**COMMONWEALTH OF KENTUCKY
TRANSPORTATION CABINET**
Frankfort, Kentucky 40622
www.transportation.ky.gov/

CALL NO. 301
CONTRACT ID NO. 171239
ADDENDUM # 1

Subject: Menifee County, FD04 SPP 083 0036 002-005
Letting September 29, 2017

- (1) Revised - Plans - R2D, R5, R9, R23, R44, & R45
- (2) Revised - Bid Items - Pages 74-75 of 75

COUNTY OF	ITEM NO.	SHEET NO.
MENIFEE	10-8001.10	R2d

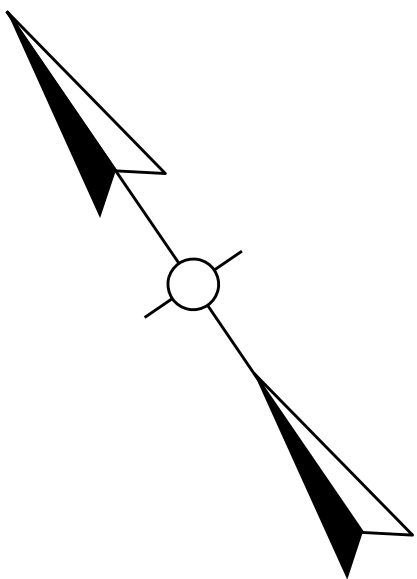
REVISED 09/18/2017

COUNTY OF	ITEM NO.	SHEET NO.
MENIFEE	10-8001.10	R5

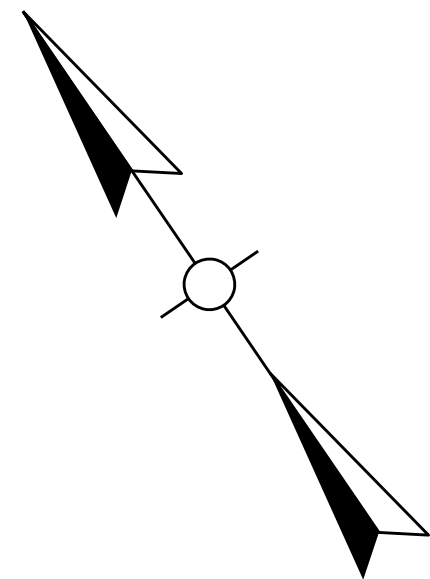
R/W REV. NO. 2, MARCH 13, 2013
 REVISED 09/18/2017

KY 36 & STONEQUARRY ROAD
STA. 20+00 TO STA. 32+82
PHASE 2 MAINTENANCE OF TRAFFIC

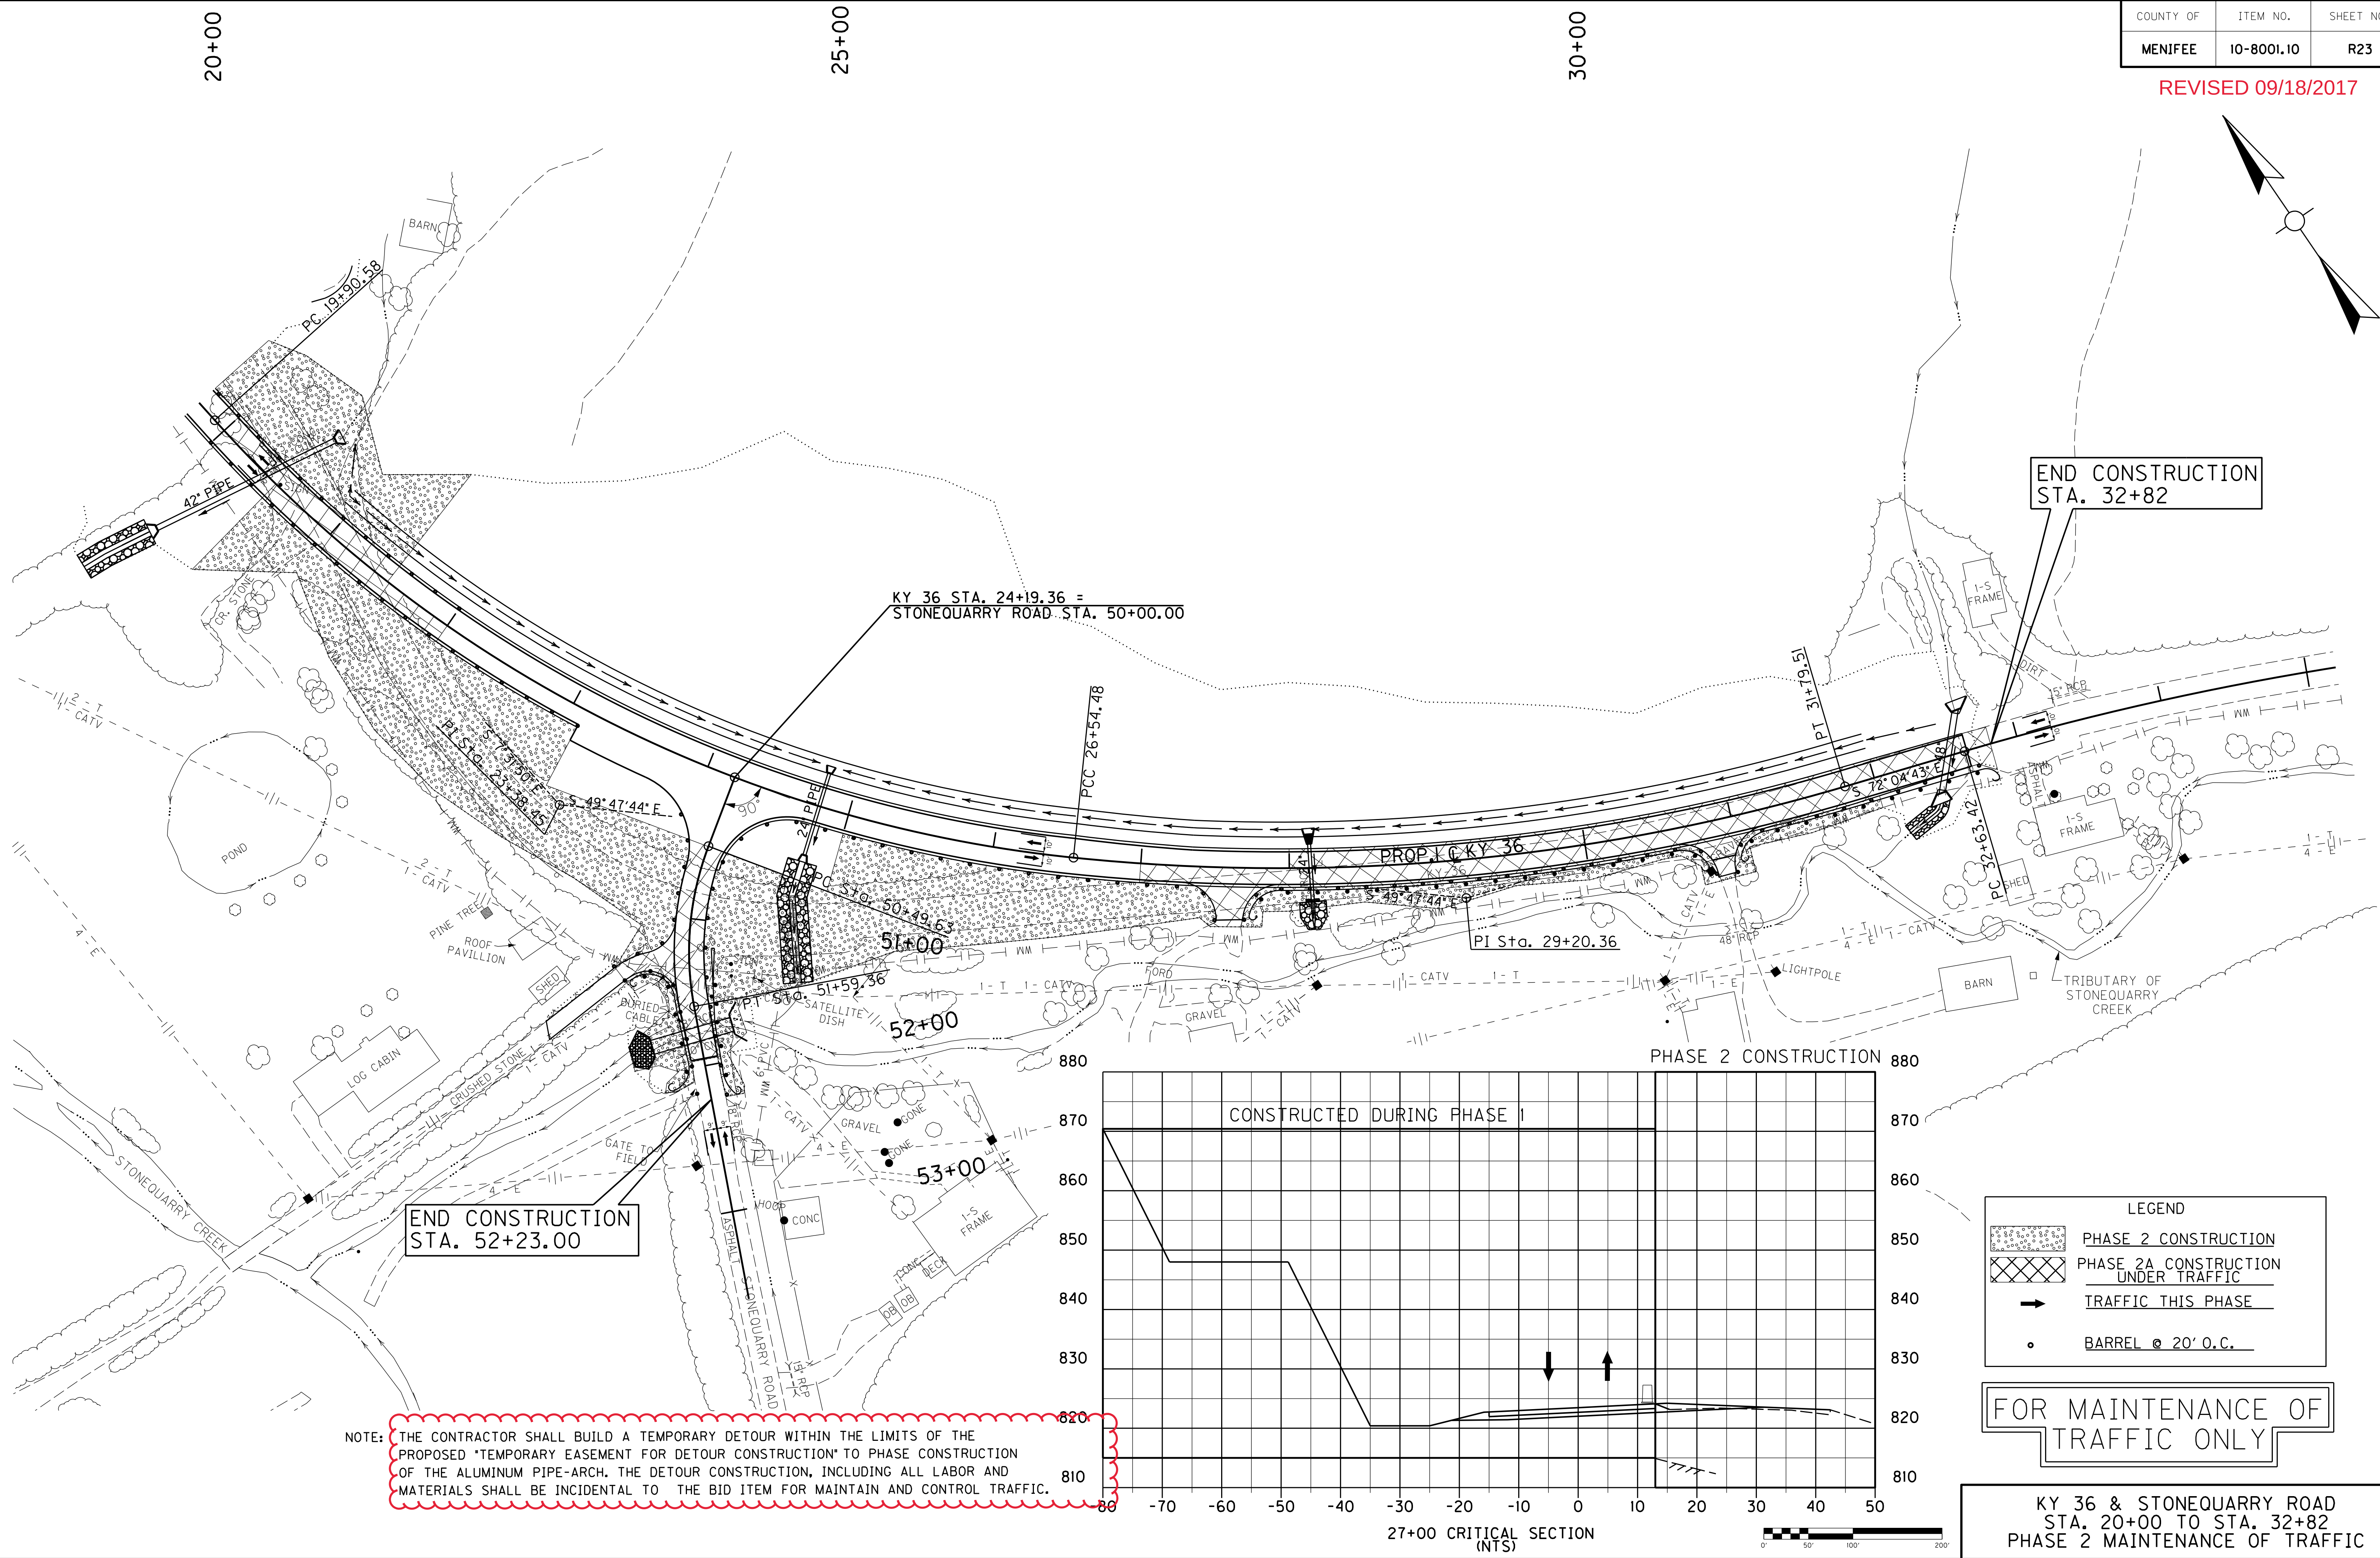
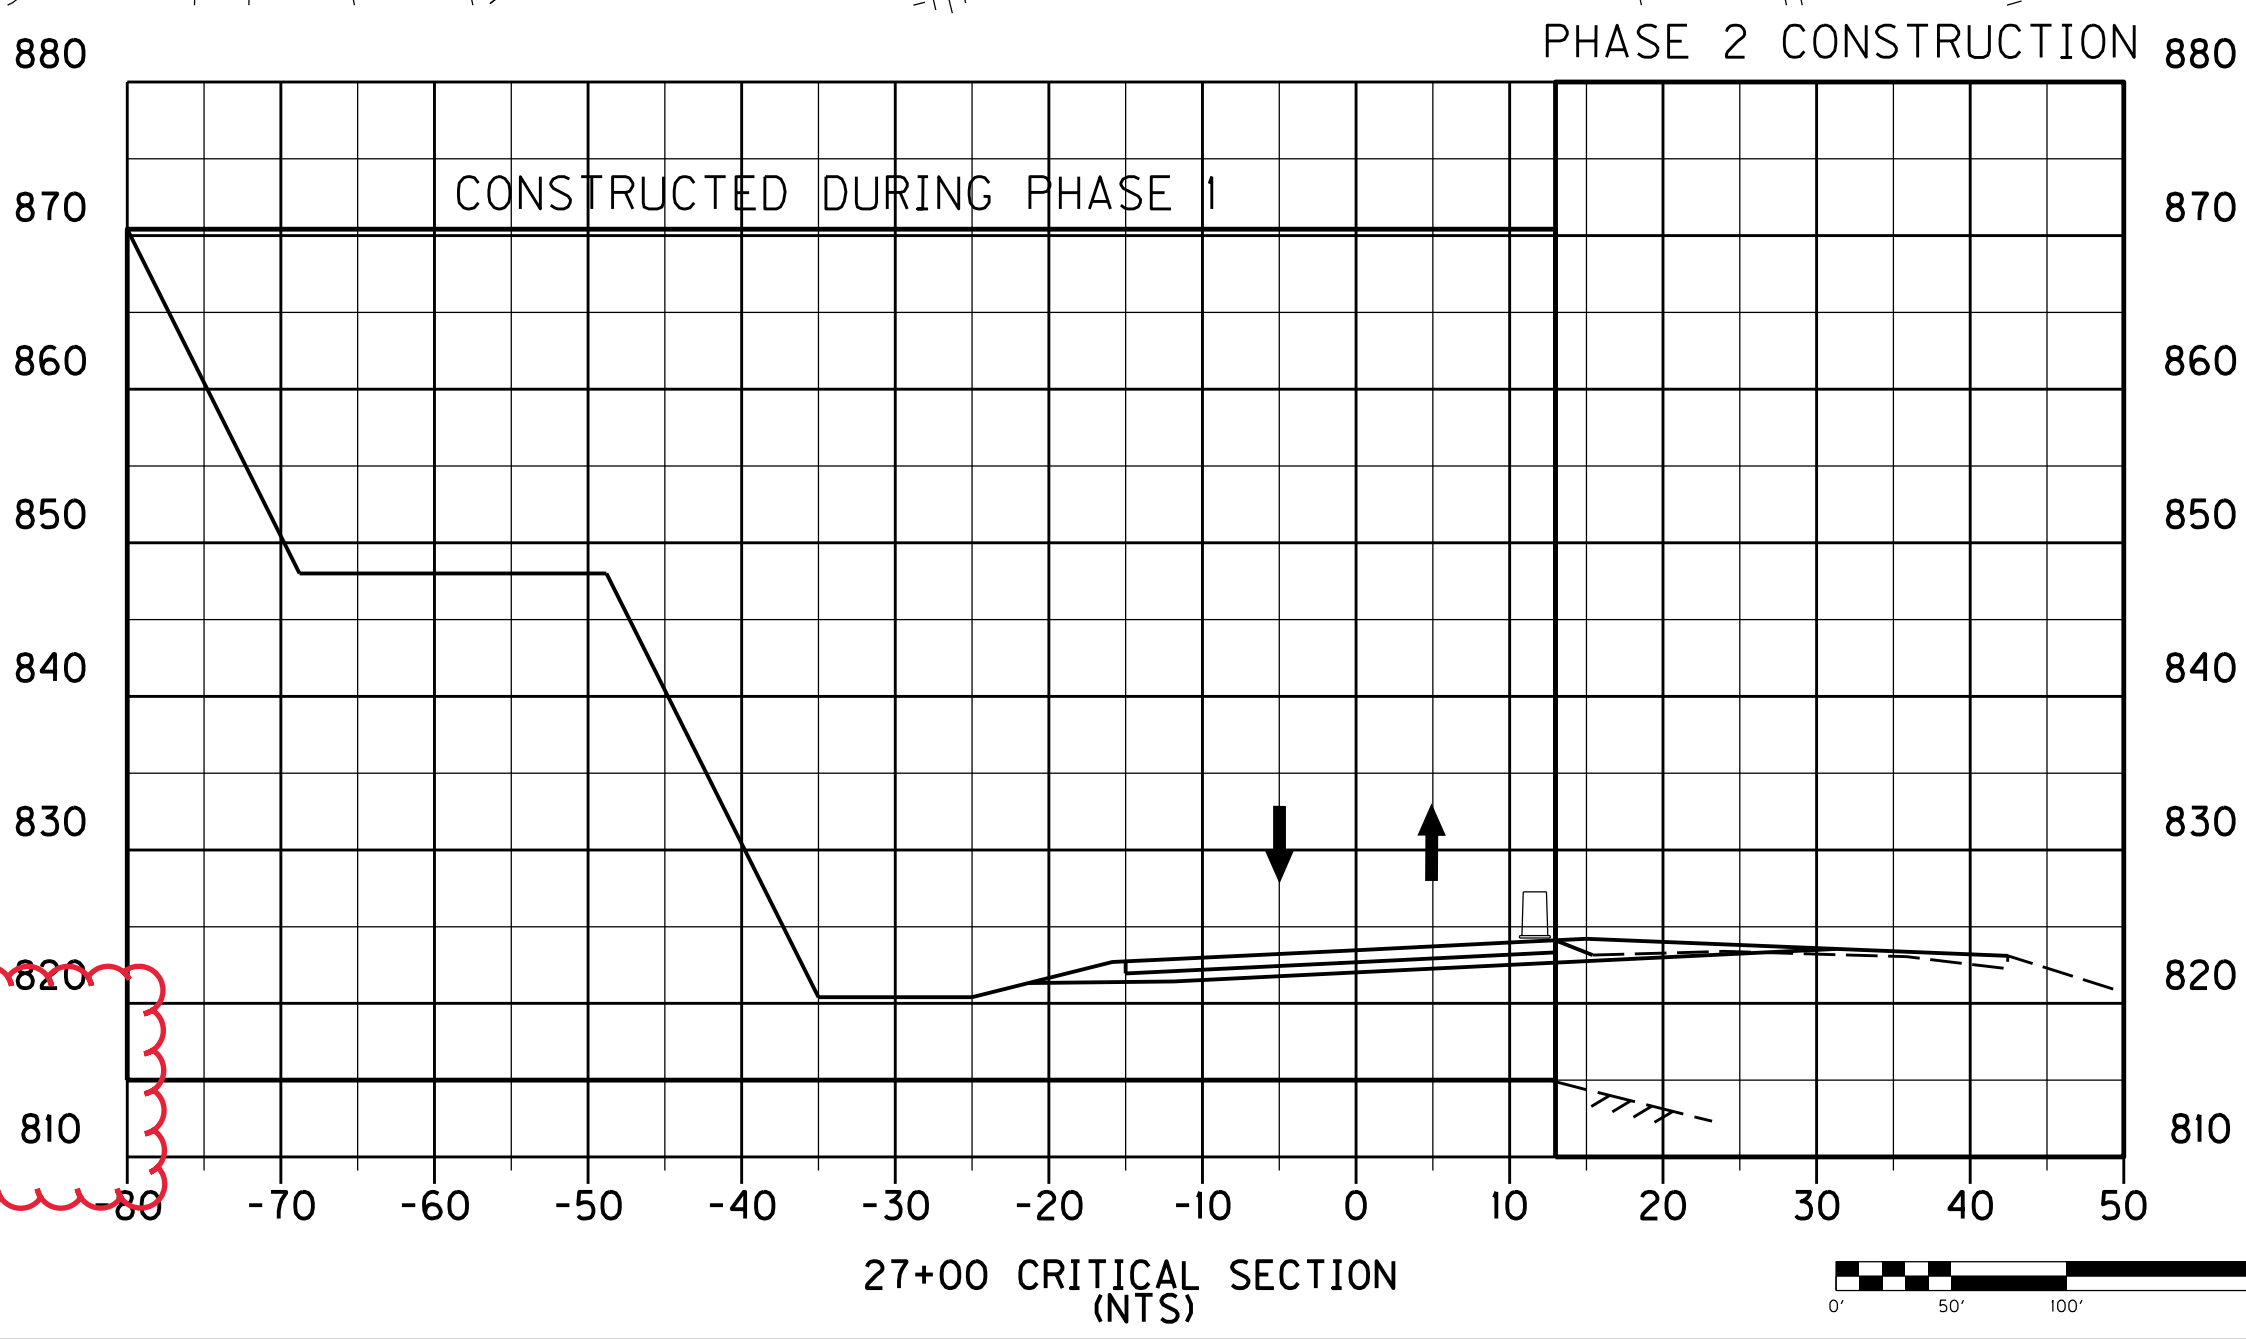
REVISED 09/18/2017
